Access Compliance Report

Public Rights-of-Way (Curb Ramps)

Intersection ID: 26090	Main Street: PROVIDENCE_RD	Cross Street: LAKESIDE_DR	Location: NE
ADA ID: 8E33A86A4699	Ramp Type: Perpendicular	Initial Pass/Fail: Fail	Overall Compliance: No
			Severity Score: 46.25

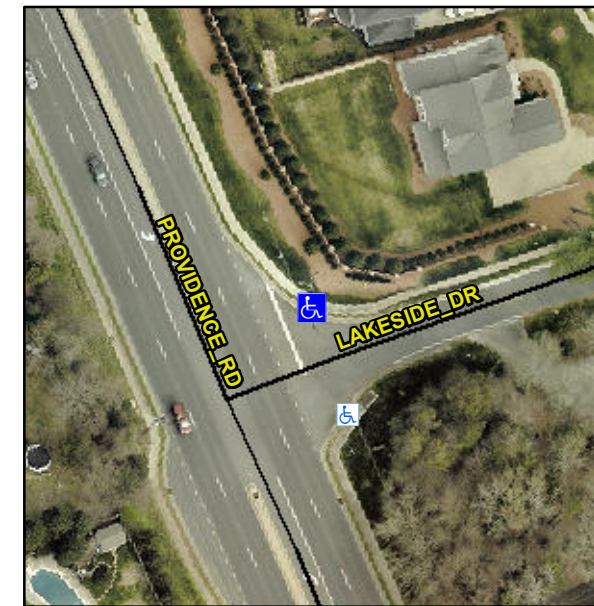
Not Found, R304.5.1, R304.2.2, R304.5.3

Compliance	Description	Data	Compliance	Description	Data
N/A	Ramp Length (in)	75.0	No	Ramp Slope (%)	9.8
No	Ramp Width (in)	39.0	No	Ramp XSlope (%)	8.4
N/A	Flare Type LT	N/A	N/A	Flare Type RT	N/A
N/A	Flare Slope LT (%)	N/A	N/A	Flare Slope RT (%)	N/A
N/A	Flare Traversable LT?	N/A	N/A	Flare Traversable RT?	N/A
N/A	Landing Length (in)	N/A	N/A	DWS Provided?	N/A
N/A	Landing Width (in)	N/A	N/A	DWS Contrast?	N/A
N/A	Landing Slope (%)	N/A	N/A	DWS Length (in)	N/A
N/A	Landing X Slope (%)	N/A	N/A	DWS Full Width?	N/A
N/A	Landing Curb? (Y/N)	N/A	N/A	DWS Offset (in)	N/A
N/A	Shared Landing?	N/A			
N/A	Gutter Ponding?	N/A	N/A	Gutter Slope (%)	N/A
N/A	Gutter Lip Ht (in)	N/A	N/A	Gutter X Slope (%)	N/A
N/A	Painted X Walk1?	No	N/A	Painted X Walk2?	N/A
	X Walk 1 Direction	To S		X Walk 2 Direction	N/A
N/A	X Walk 1 Width (in)	N/A	N/A	X Walk 2 Width (in)	N/A
	X Walk 1 Slope (%)	6.3		X Walk 2 Slope (%)	N/A
	X Walk 1 X Slope (%)	3.9		X Walk 2 X Slope (%)	N/A

Remove & Replace Entire Ramp.
